dRICH Envelope Updates

Merge request:

https://eicweb.phy.anl.gov/EIC/detectors/ecce/-/merge_requests/33/diffs

Before → After

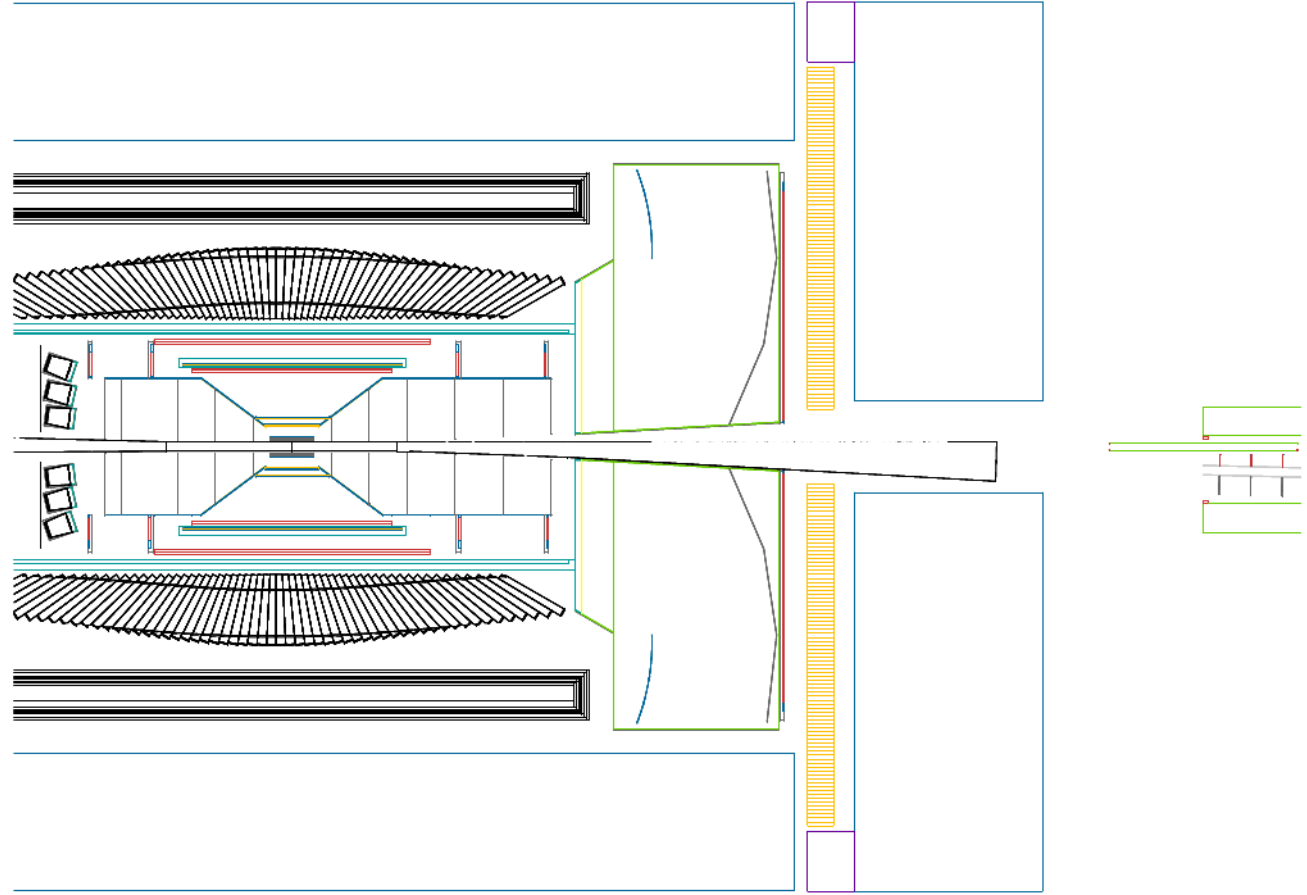
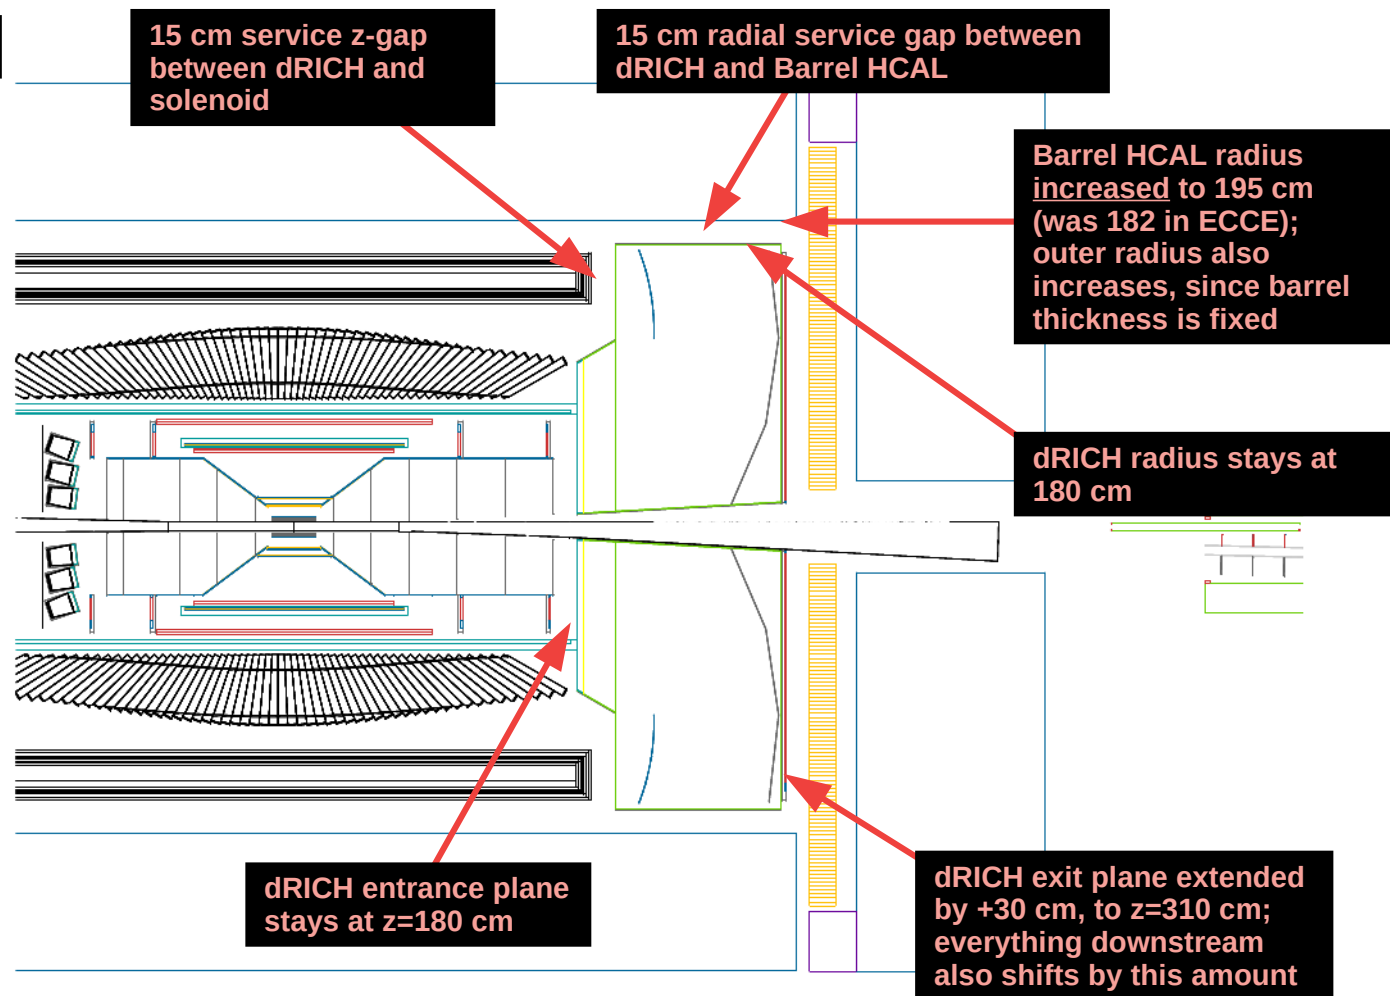
Before changes: from ecce git repo branch main

zmin	=	180
zmax	=	280
snoutLength	=	20
tankLength	=	80
radius	=	180

After changes: from ecce git repo branch 18-drch-increase-z-length-and-add-space-for-services

zmin	=	180
zmax	=	310
snoutLength	=	24.5
tankLength	=	105.5
radius	=	180

CHANGES

zmin	= 180
zmax	= 310
snoutLength	= 24.5
tankLength	= 105.5
radius	= 180
